State of Illinois
CAPITAL DEVELOPMENT BOARD

SUBJECT: ADDENDUM NO. FIVE TO THE BIDDING DOCUMENTS FOR

CDB-756-030-001
Illinois Treasury Department Relocation
One East Old State Capitol Plaza
Springfield, Illinois 62701

THIRD FLOOR PLAN

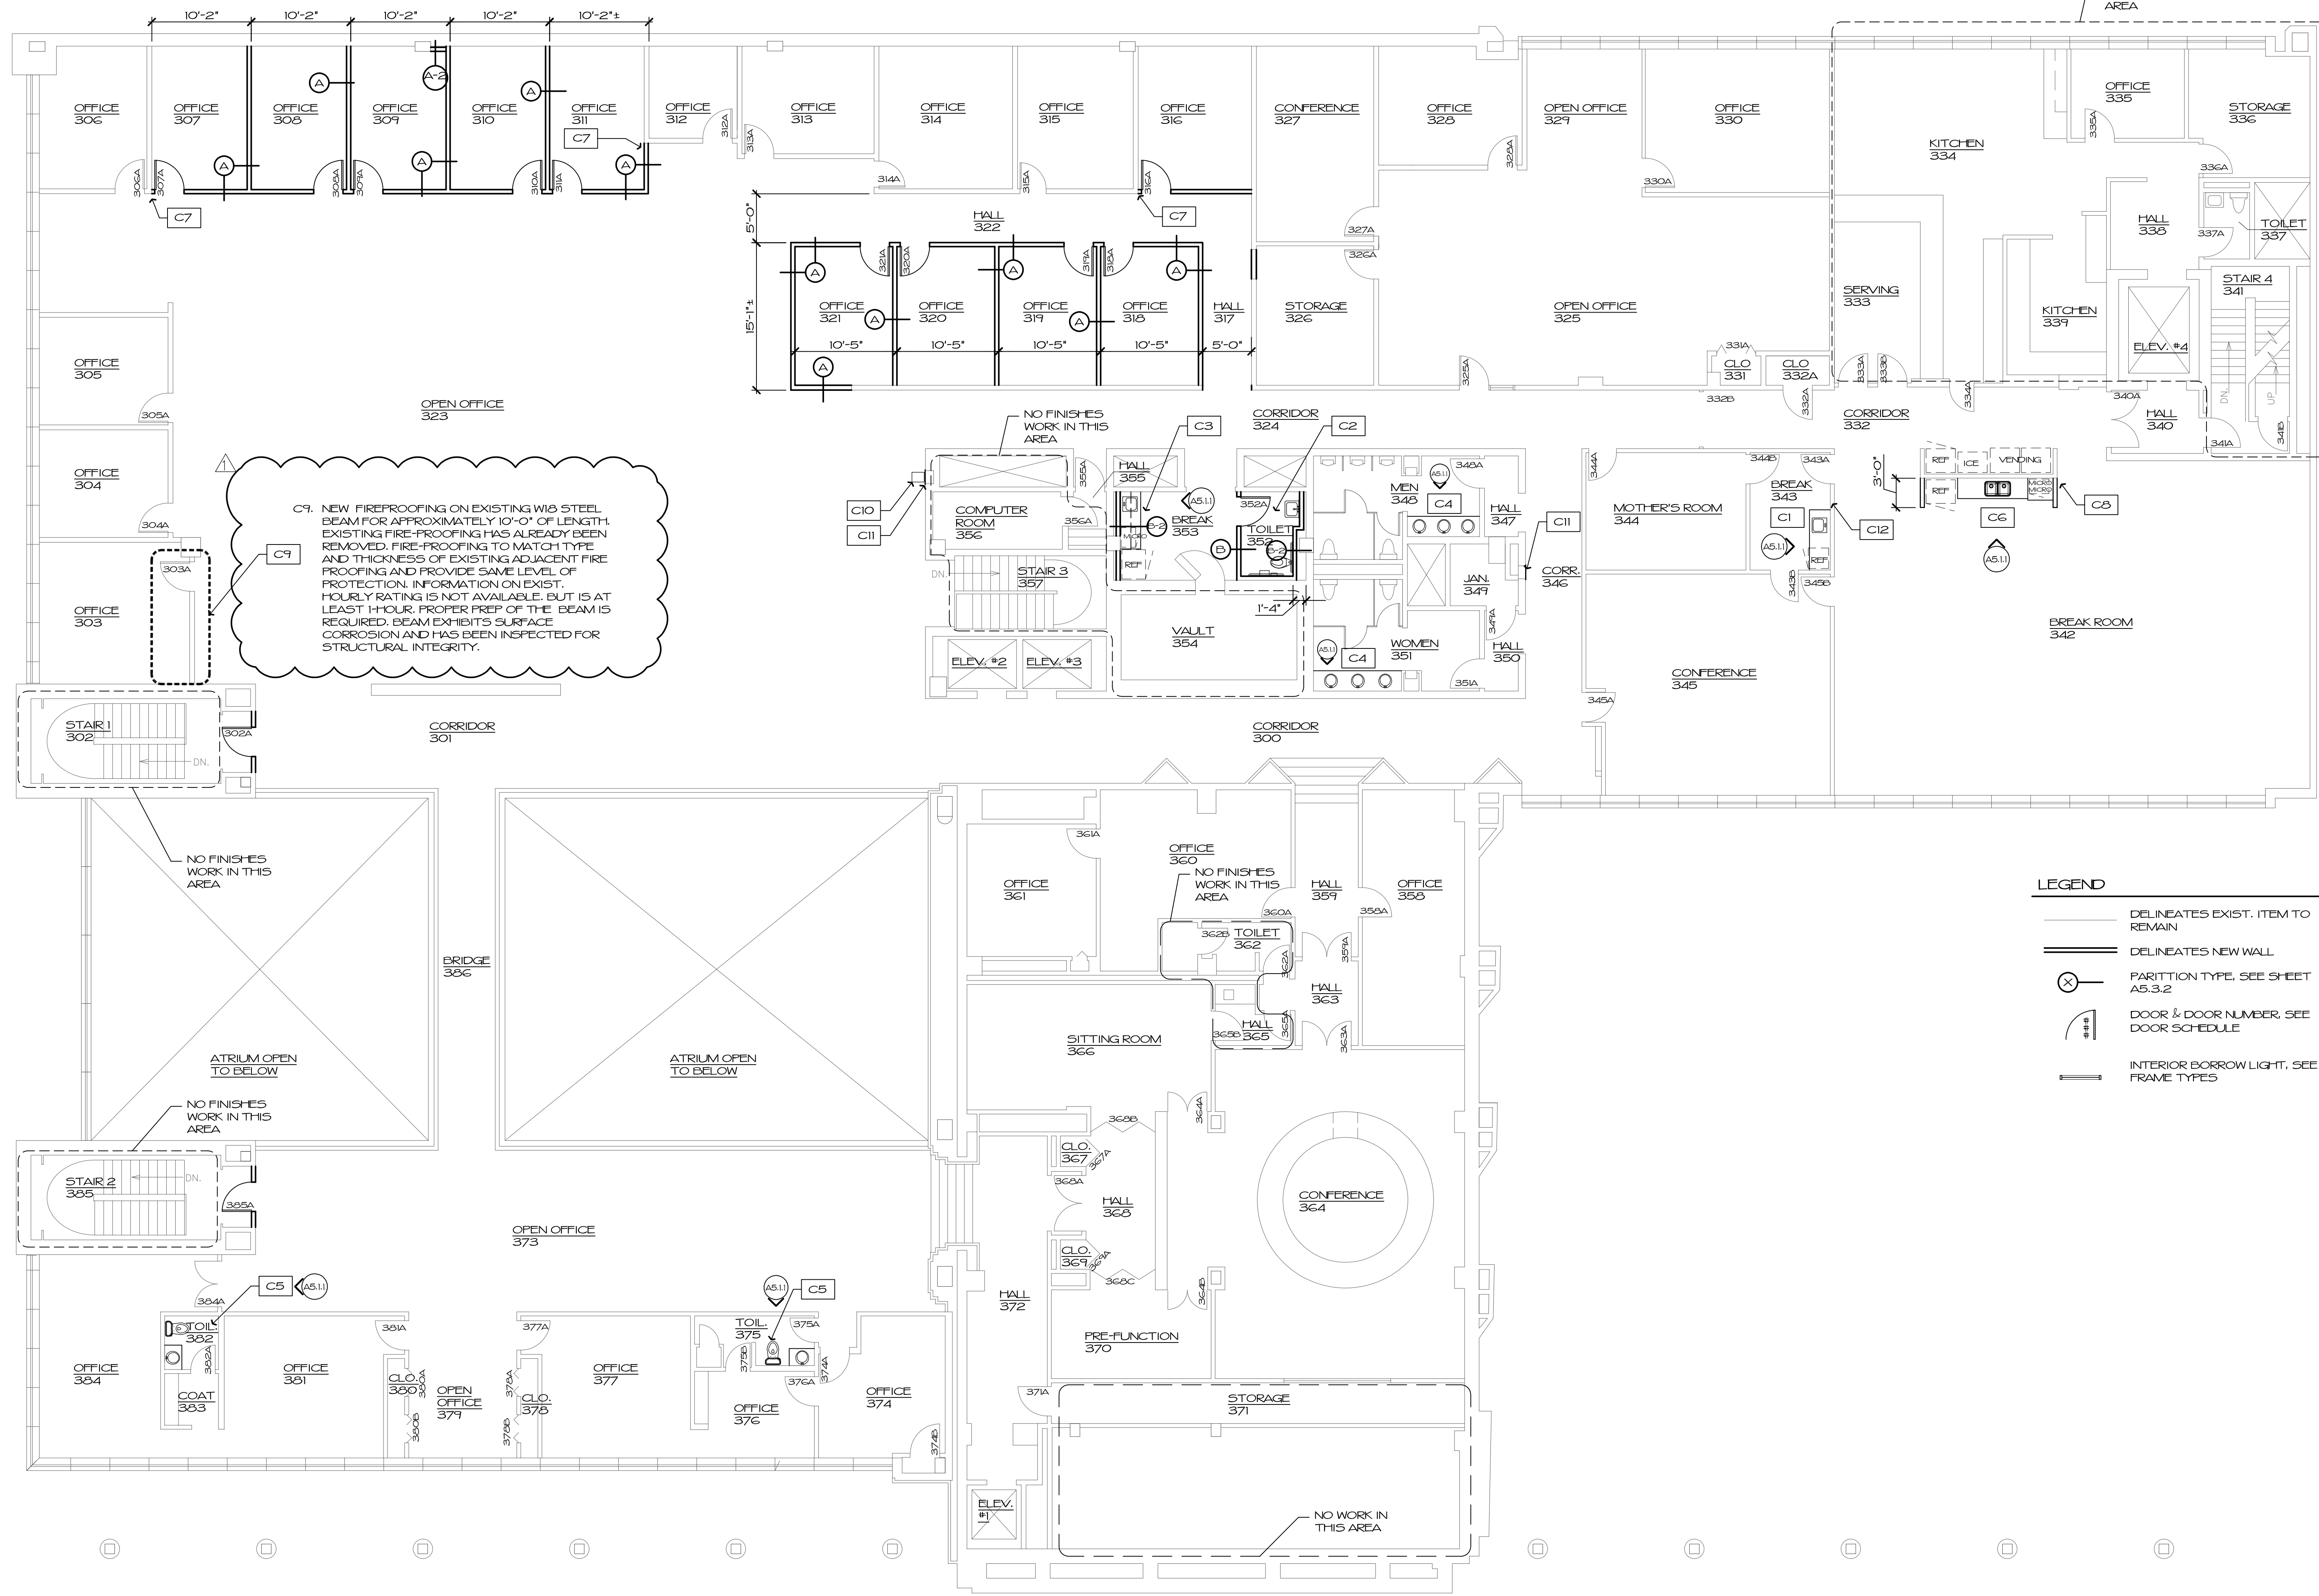
- 1. SHEET A2.1.3 – "3rd Floor Plan"
 - a. Revision delta #1.
 - b. Construction note #C9 revised to include additional information about the existing steel beam and fireproofing.
 - c. See attached revised drawing.
- 2. SHEET A7.1.2 – "Room Finish Schedule – 2nd Floor and 3rd Floor (Partial)"
 - a. Revision delta #1.
 - b. Added finishes at Open Office 243, Office #244, Office #264, Office #265, and Office #266.
 - c. Revised accent wall location at Office #262.
 - d. See attached revised drawing.

- i. *There will be a new utility sink in Print Room 074 at the location of an existing electric water cooler that will be removed.*
 - b. Drawing A2.1.3 Note C9 calls for replacing the fireproofing, Can you provide approximate square footage for this work?

- i. *Note C9 on sheet A2.1.3 has been expanded. See the revised sheet issued in this addendum.*
 - c. Drawings A5.3.2 Note 1 calls for 18 ga studs everywhere. Please confirm this is what you want.

C9. NEW FIREPROOFING ON EXISTING WIS STEEL BEAM FOR APPROXIMATELY 10'-0" OF LENGTH. EXISTING FIRE-PROOFING HAS ALREADY BEEN REMOVED. FIRE-PROOFING TO MATCH TYPE AND THICKNESS OF EXISTING ADJACENT FIRE PROOFING AND PROVIDE SAME LEVEL OF PROTECTION. INFORMATION ON EXIST. HOURLY RATING IS NOT AVAILABLE, BUT IS AT LEAST 1 HOUR. PROPER PREP. OF THE BEAM IS REQUIRED. BEAM EXHIBITS SURFACE CORROSION AND HAS BEEN INSPECTED FOR STRUCTURAL INTEGRITY.

MATERIALS LIST

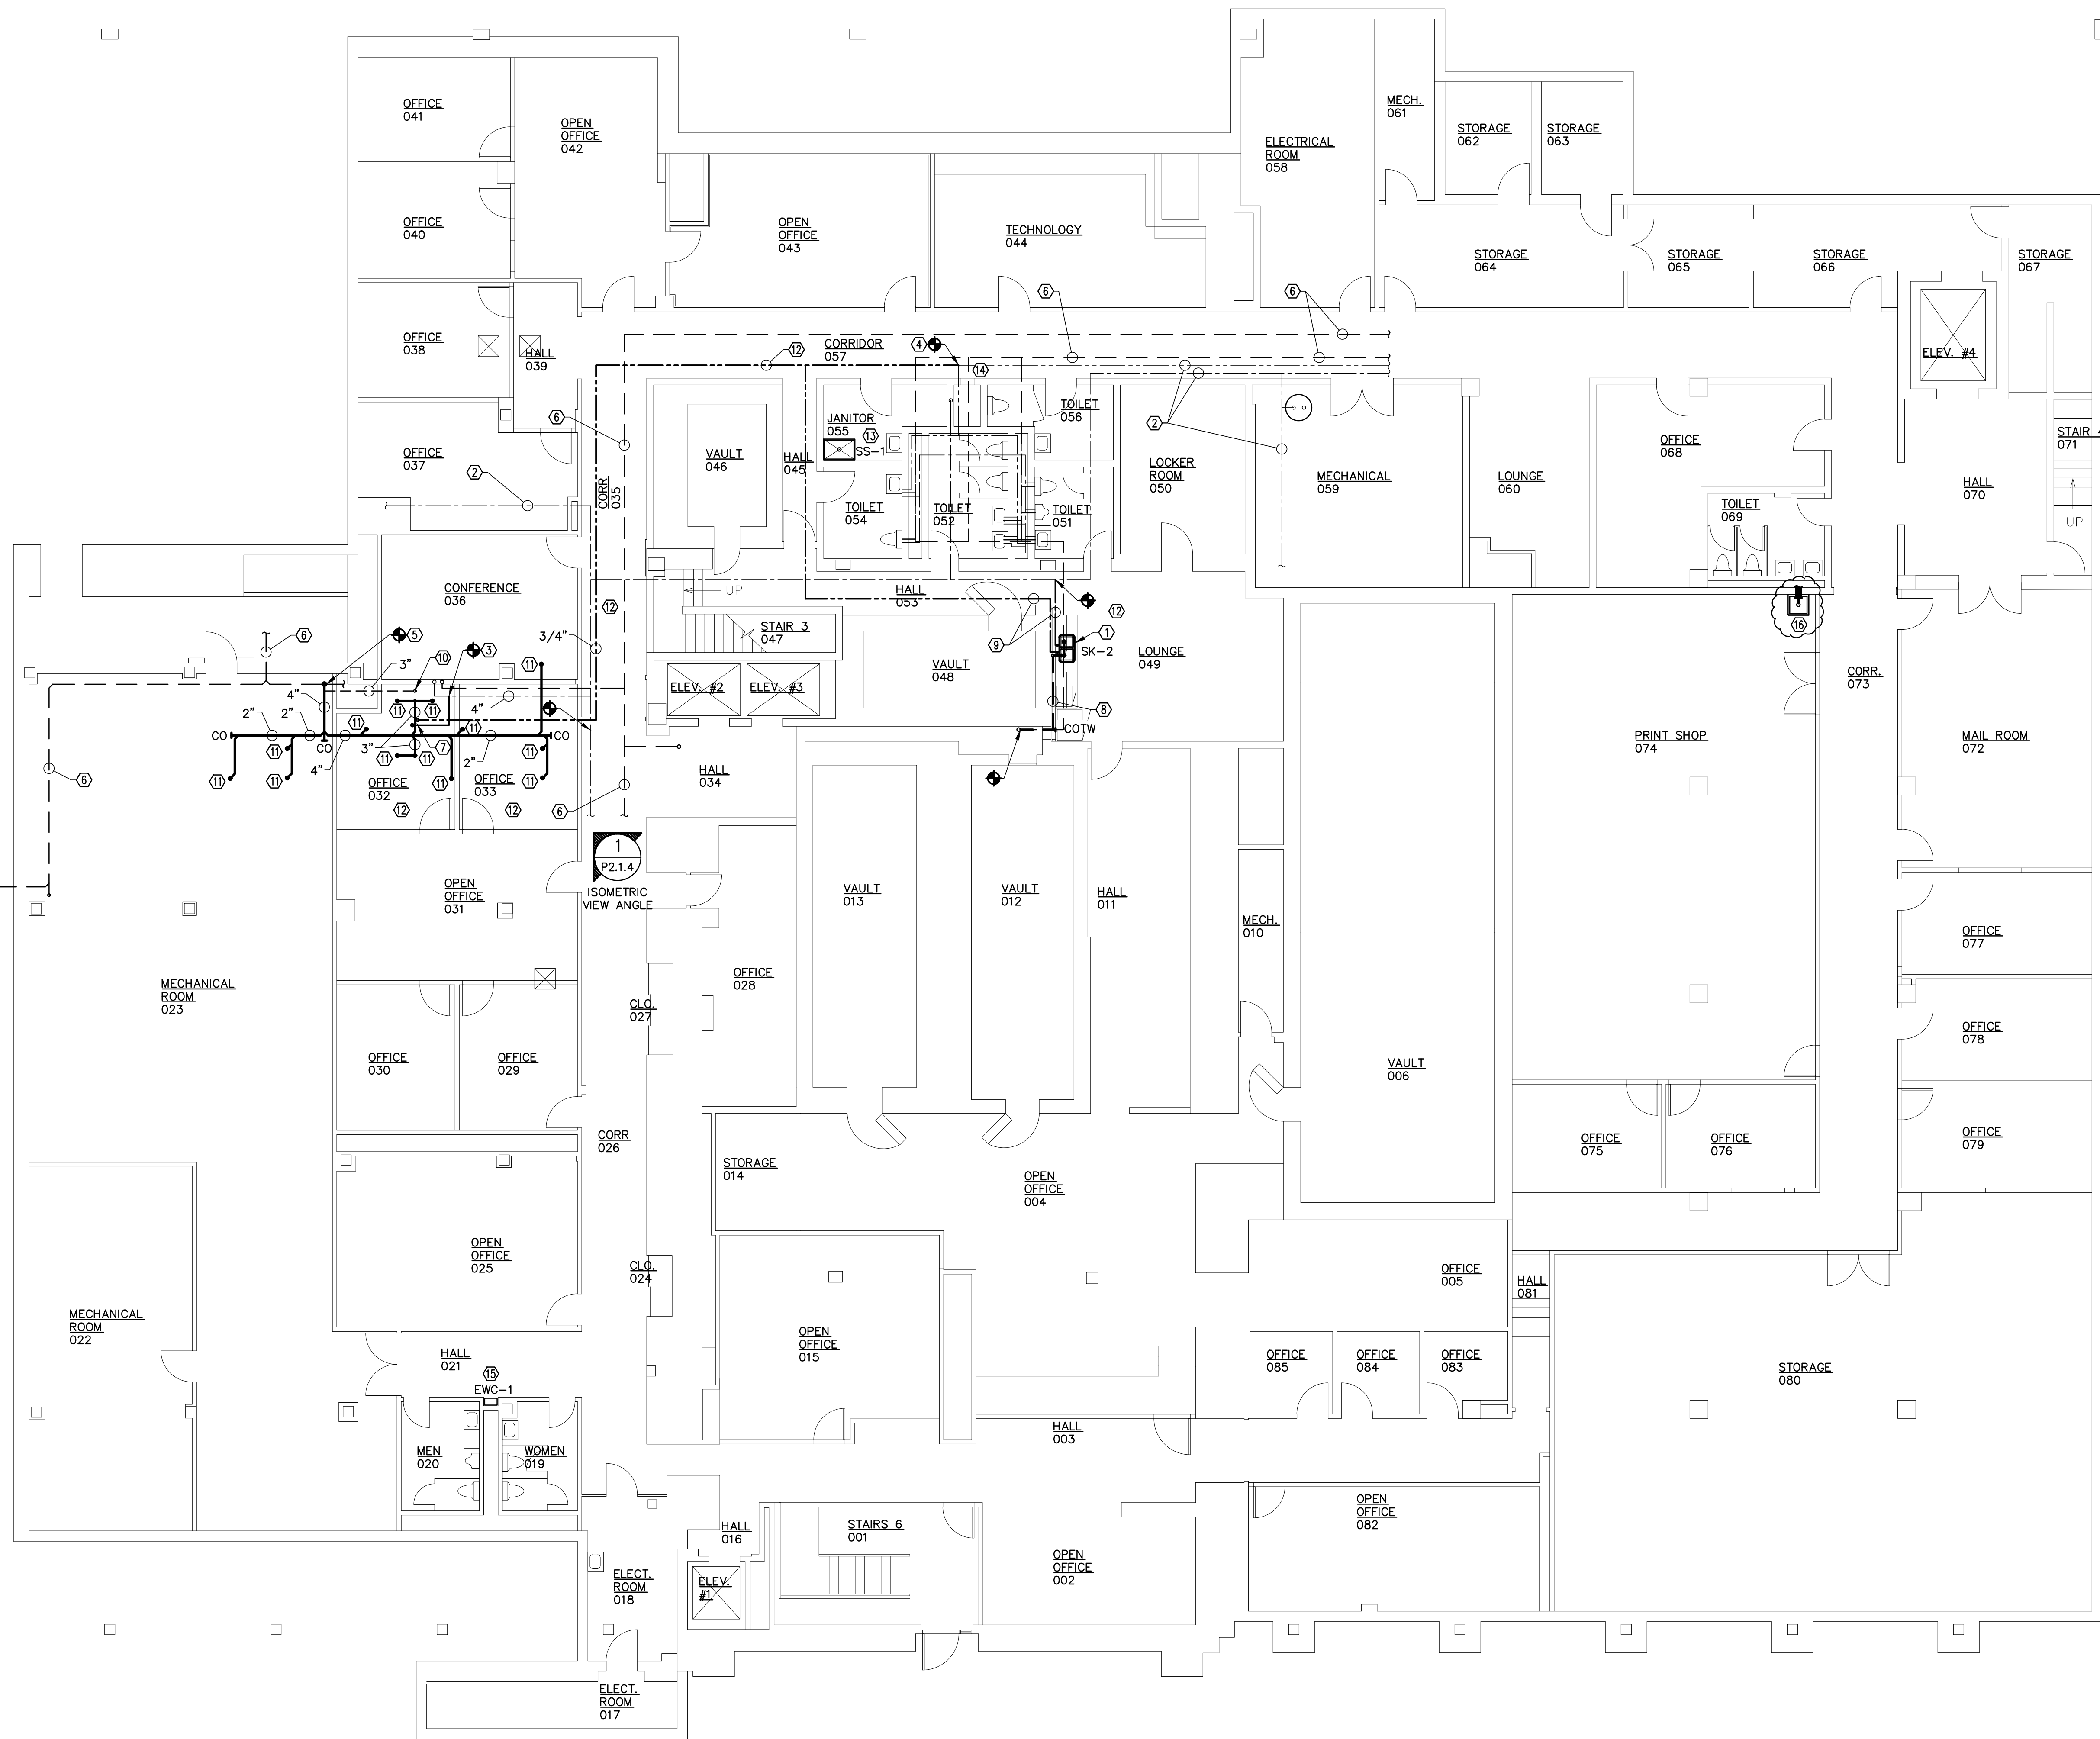
3. SHEET A7.1.3 – “Room Finish Schedule – 3rd Floor (Continued)”
 - a. Revision delta #2.
 - b. Revised flooring at Office #377.
 - c. See attached revised drawing.

- i. *The Room Finish Schedule has been revised to include these rooms. See the revised drawing issued in this addendum.*
- h. Room 377 on drawing A7.3.3. shows as existing wood. This same room on the Room Finish Schedule on A7.1.3 shows CPT-T.

- i. *The flooring designation has been revised. See the revised drawing issued in this addendum.*
- i. On the Reflected Ceiling Plan Removal sheets it says, "Exist. 12" x 12" concealed spline ceiling system to be removed." Could you describe what is above these 12" x 12" ceiling tiles? Is there a metal grid system? Is it wood framing?
